CHANGE ORDER NUMBER 1

4B: Third Party Accommodation. Third party requested work. This Change Order adds relocation of the existing Brushy Creek Municipal Utility District (BCMUD) water line along CR 176 and revises the City of Georgetown water line relocations on the project.

Project: 1901-285Roadway: CR 176 at RM 2243

WILLIAMSON COUNTY
CR 176 AT RM 2243 INTERSECTION
COG AND BCMUD WATER ADJUSTMENTS
AND BCMUD 24" RAW WATERLINE RELOCATION

BCMUD 24" RAW WL RELOCATION

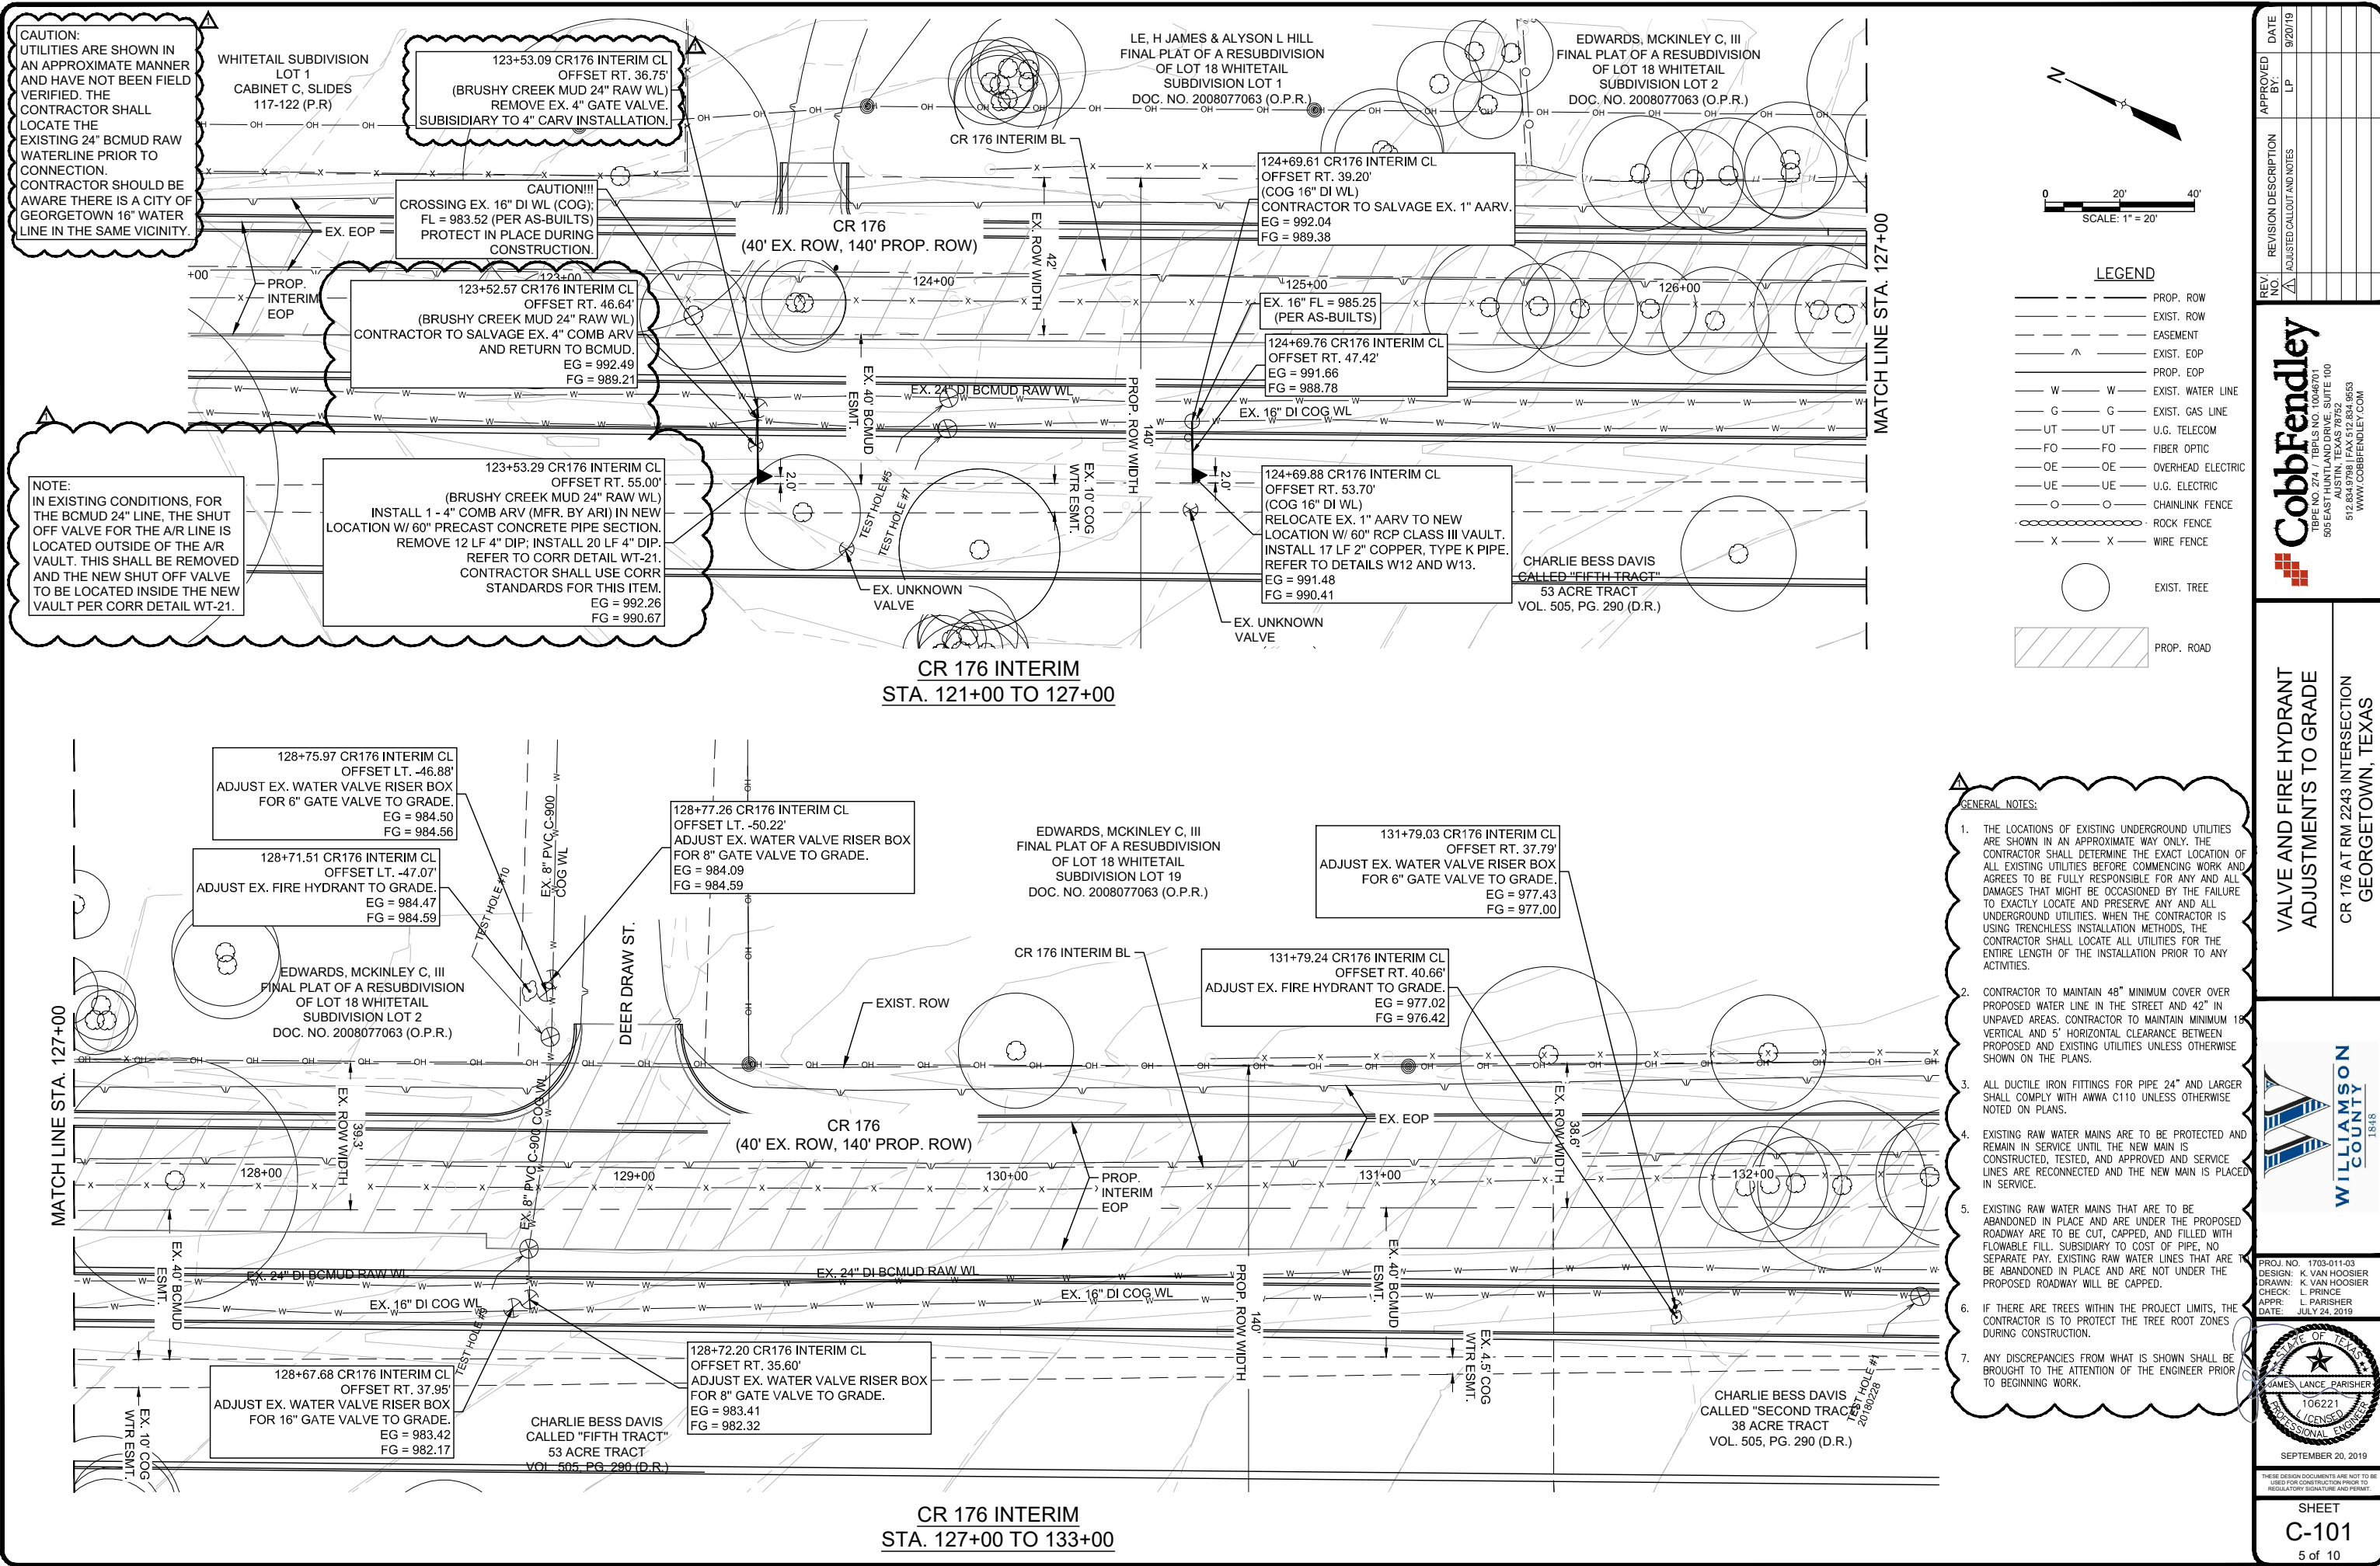
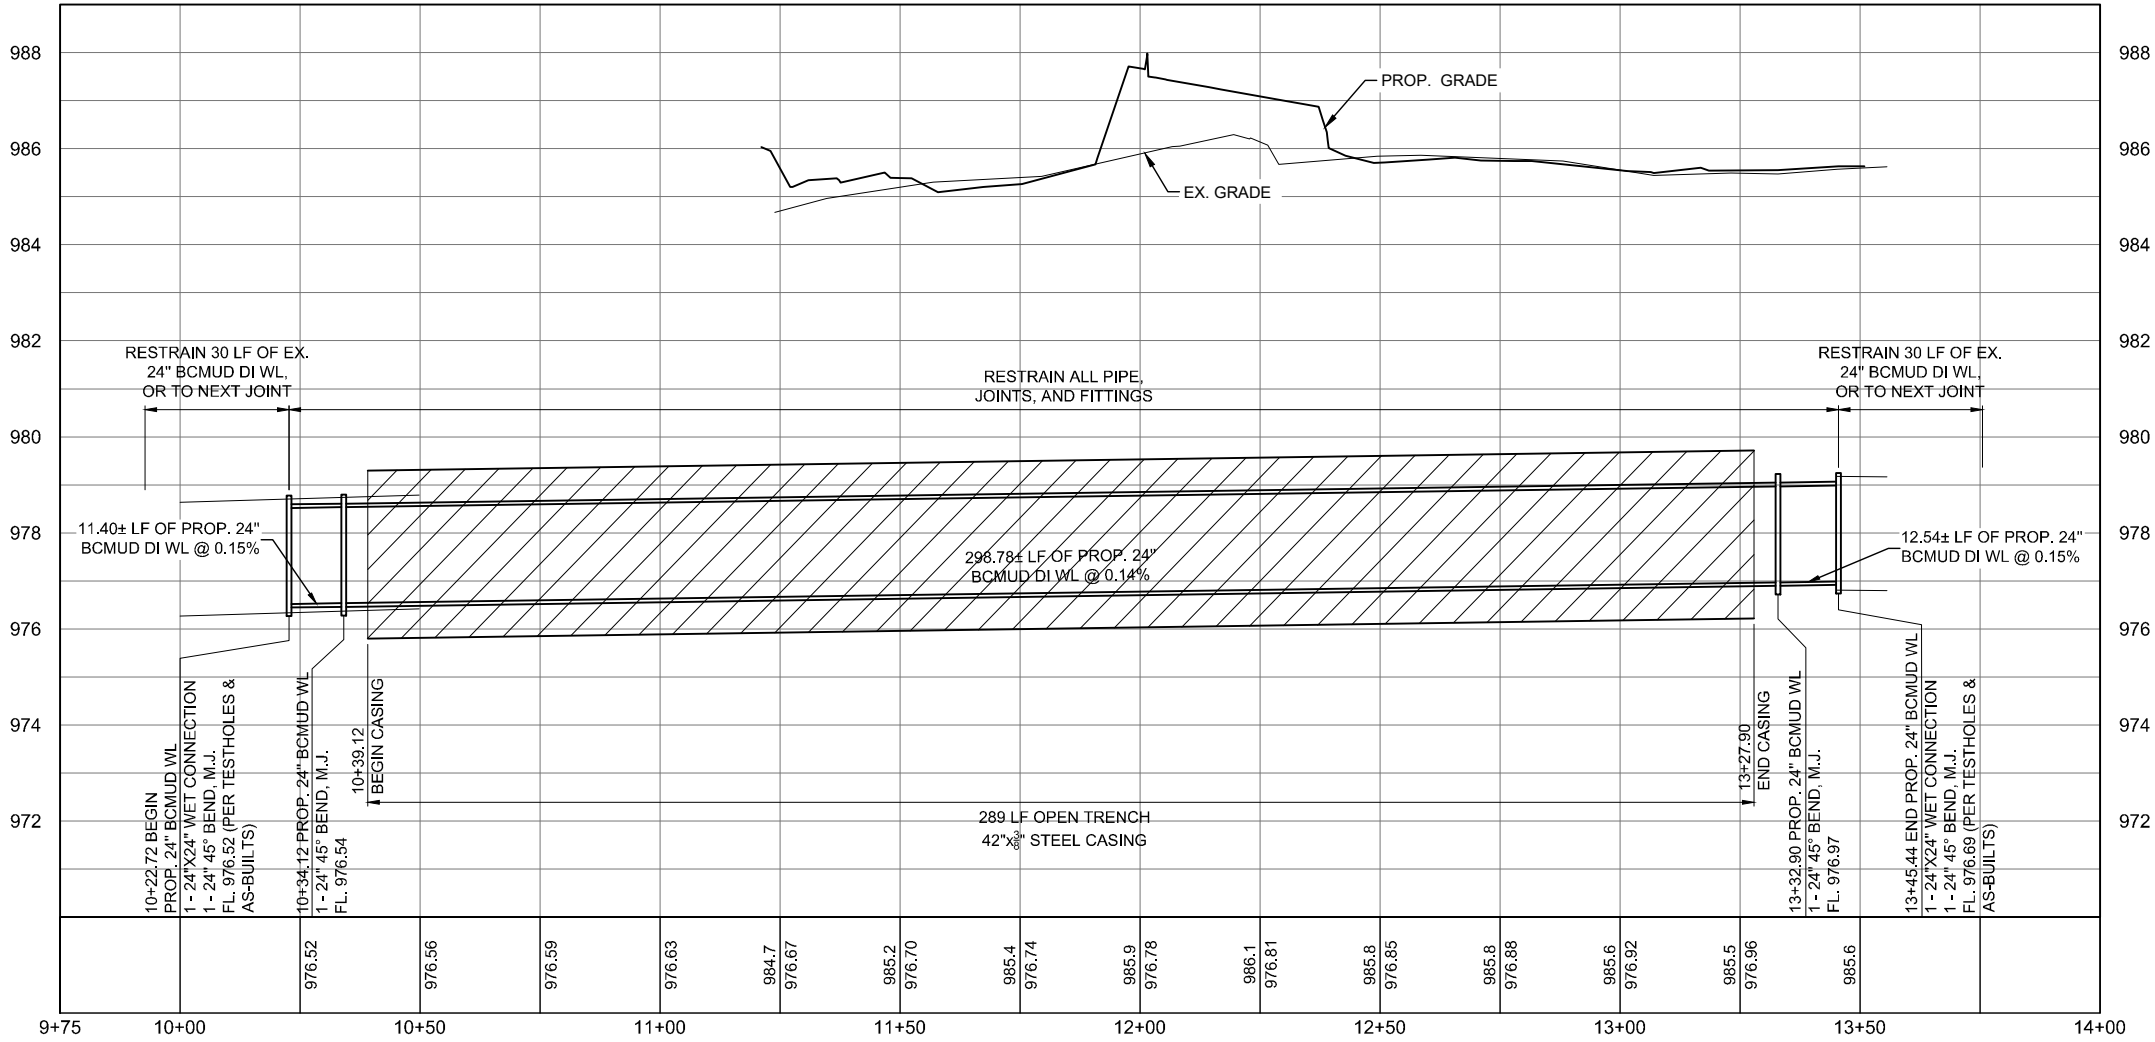
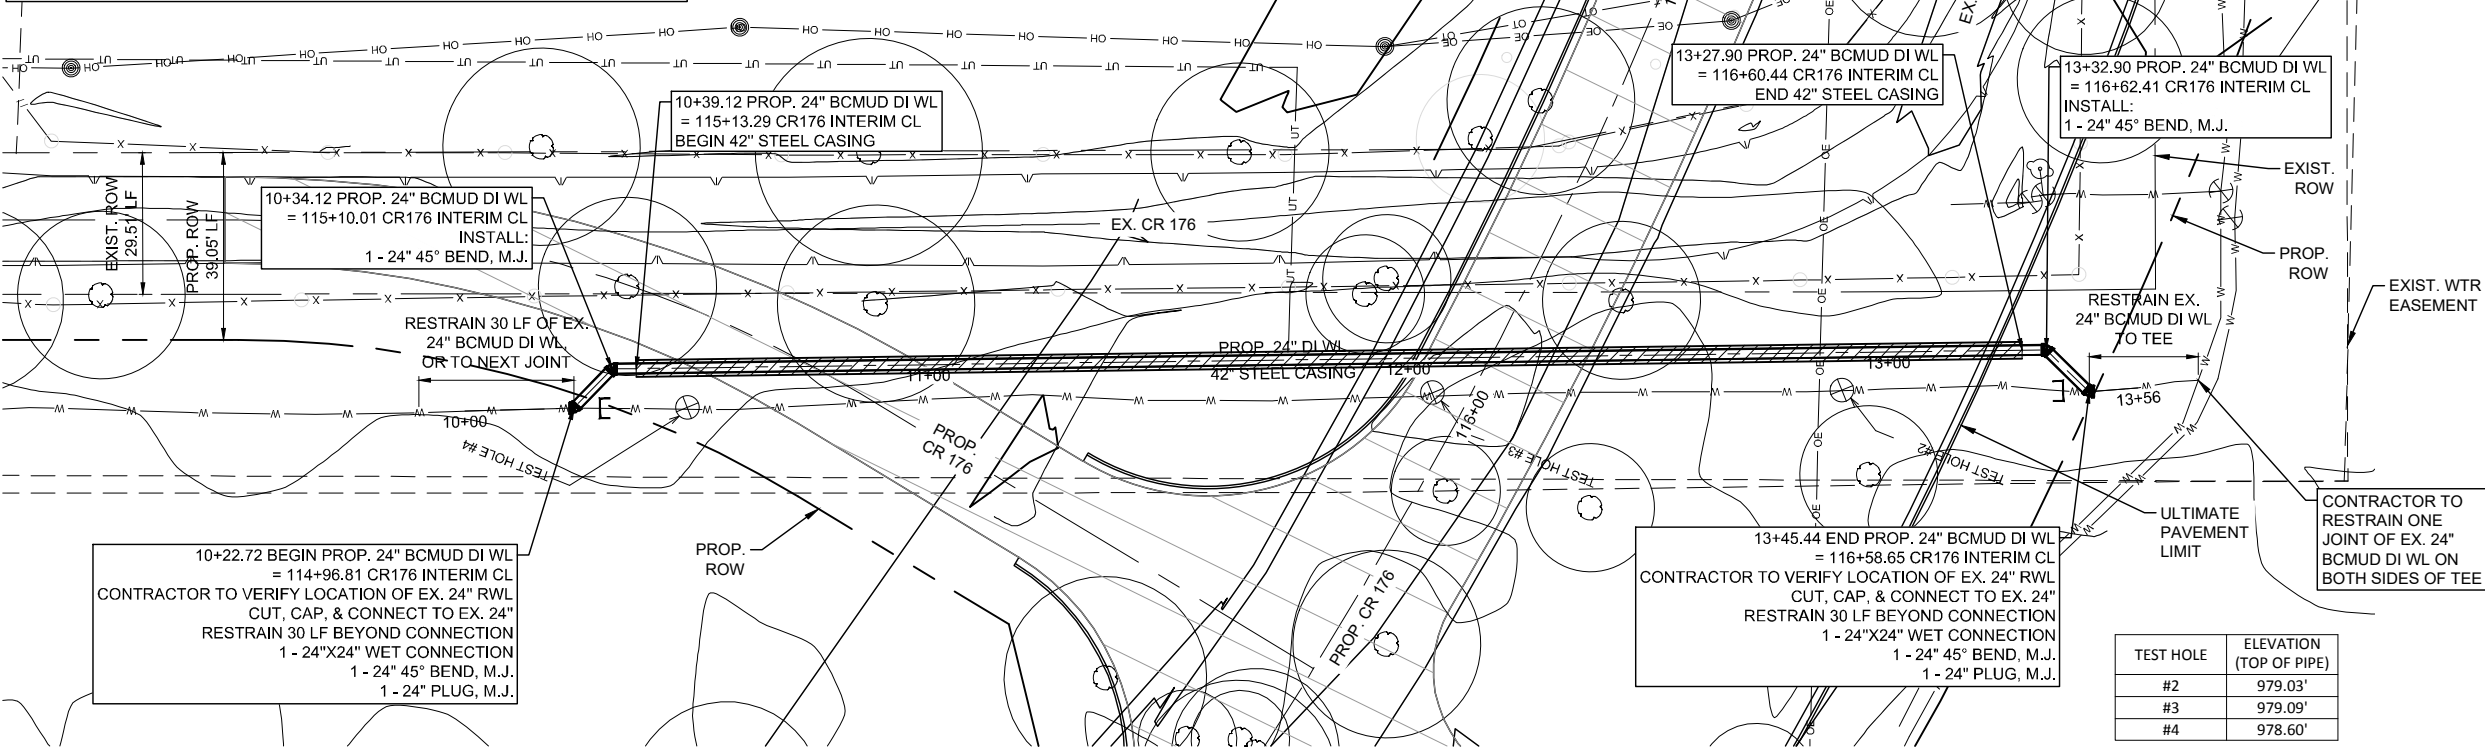
The relocations for BCMUD include installing a new portion of water line in an encasement because the new roadway crosses the water line and adding a 4" Combination Air Release Valve Assembly (CARV), salvaging the old CARV and removing the existing 4" Gate Valve. The revisions to the City of Georgetown water line include adjustment of the existing 2" line and deletes items to adjust the existing 4" water line.

REVISION DESCRIPTION
NO. 1
ADDED NEW SHEET

2. CONTRACTOR TO MAINTAIN 48" MINIMUM COVER OVER PROPOSED WATER LINE IN THE STREET AND 42" IN UNPAVED AREAS. CONTRACTOR TO MAINTAIN MINIMUM 18" VERTICAL AND 5' HORIZONTAL CLEARANCE BETWEEN PROPOSED AND EXISTING UTILITIES UNLESS OTHERWISE SHOWN ON THE PLANS.

3. ALL DUCTILE IRON FITTINGS FOR PIPE 24" AND LARGER SHALL COMPLY WITH AWWA C110 UNLESS OTHERWISE NOTED ON PLANS.
4. EXISTING RAW WATER MAINS ARE TO BE PROTECTED AND REMAIN IN SERVICE UNTIL THE NEW MAIN IS CONSTRUCTED, TESTED, AND APPROVED AND SERVICE LINES ARE RECONNECTED AND THE NEW MAIN IS PLACED IN SERVICE.
